"AST PROM CHANGE"

### I. APPLICABILITY

VPR-3's with AST Servo PWA, Part Number 1467070-01 through -03.

MODEL VPR-3
BULLETIN NO. 60961 SHEET 2 OF 2
DATE 6/84 BP-8406-19

FIGURE 1

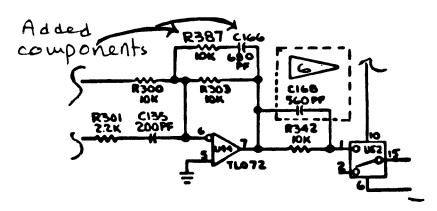
- 12. Verify that C166 is installed and is a 680 PF, 50V capacitor, P/N 064-731.
- 13. Verify that C168 (560 PF) is removed.
- 14. Remove and discard C69 (51 PF).
- 15. Replace R104 (24.3K) with a 10K, 1/8W resistor, P/N 062-983.
- 16. Place the label on the handle of PWA.
- 17. Replace C72 (510 PF) with a 470 PF, 500V, 1% mica capacitor P/N 056-291.
- 18. Replace C112 and C128 (470 PF) with 680 PF, 300V capacitors, P/N 034-677.
- 19. Replace R259 and 328 (6.49K) with 3.92K, 1/8W, 1% resistors, P/N 062-961.
- 20. Add a 10K, 1/4W, resistor, P/N 066-830 in the space marked R387. See note.
- 21. Add a 680 FF capacitor, P/N 064-731 in the space marked C166. See note.
- 22. Update schematic to reflect changes made.

Some versions of the PWA do not have spaces marked for R387 and C166. On these PWA's add the component as shown.

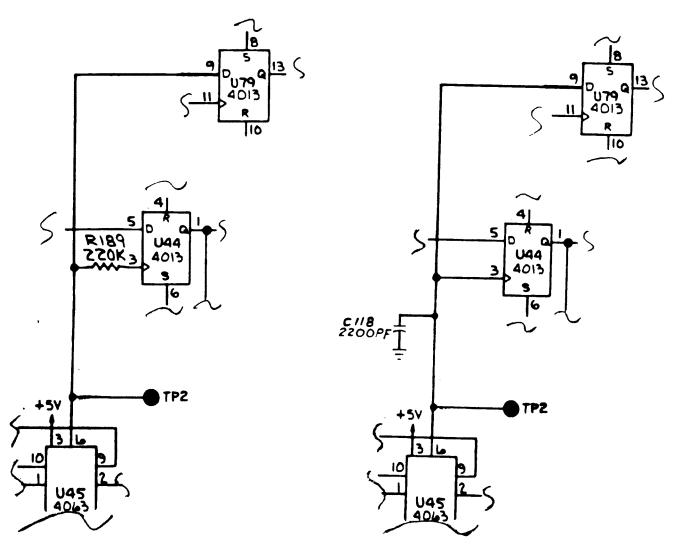
## V. PROCEDURE (See Figure 1)

- 1. Remove capacitor C118 (2200 PF).
- 2. Cut the trace at U44-3 (be sure Pin 3 is isolated).
- 3. Add a 220K resistor from U44-3 to the trace which was cut (the trace goes to U79-9 & U45-6).

FIGURE 1

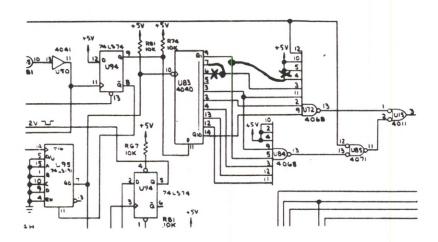
PROCEDURE (See Schematic)

- Cut trace at U83-6.
- Add a jumper wire from U83-7 to U72-3. 2.
- Cut trace at U72-4.
- Add a wire from U72-4 to U83-9.

FIGURE 1

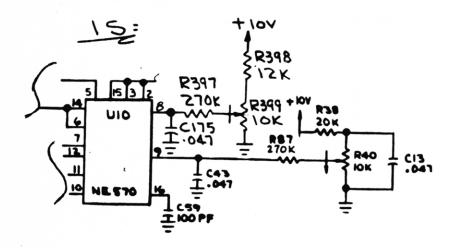
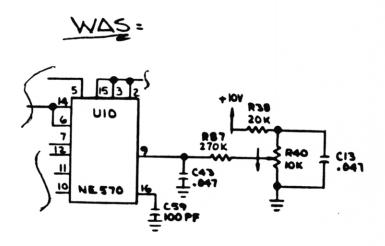
- 1. Add a 0.47 UF, 50V, 10% capacitor, P/N as shown in Figure 1. Designate the capacitor C175.
- 2. Add a 270K resistor, P/N 076-050, as shown in Figure 1. Designate it R397.
- 3. Add a 12K resistor, P/N 066-865. Designate it R398. Figure 1.
- 4. Add a 10K pot. P/N 058-565. Designate it R399. Figure 1.
- 5. Update schematic to reflect changes made.

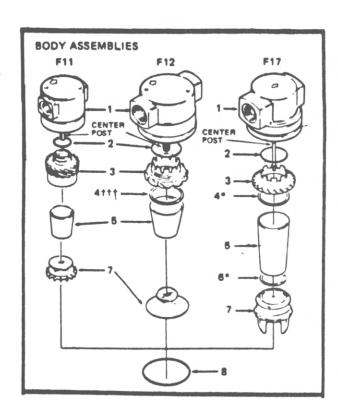
- B. MACHINES WITH AIR SYSTEM 1468060 (FILTERS LOCATED OUT SIDE AIR SYSTEM).
  - 1. See Figure 1.
  - 2. Turn off power to the VPR-3.
  - 3. Tilt down the Power Supply Chassis.

- 6. Unscrew the serrated baffle (item 7) and remove the filter element together with the white louver (item 3). Make sure that the black o-ring is also removed.

- 9. Remove the filter element by unscrewing the serrated baffle (item 7). Do not remove the white louver.
  - 10. Install the yellow Balston filter element grade CQ and secure it inside the body by screwing the filter bowl in place. Make sure that it is tight so as to form a good seal. Do not tighten excessively.
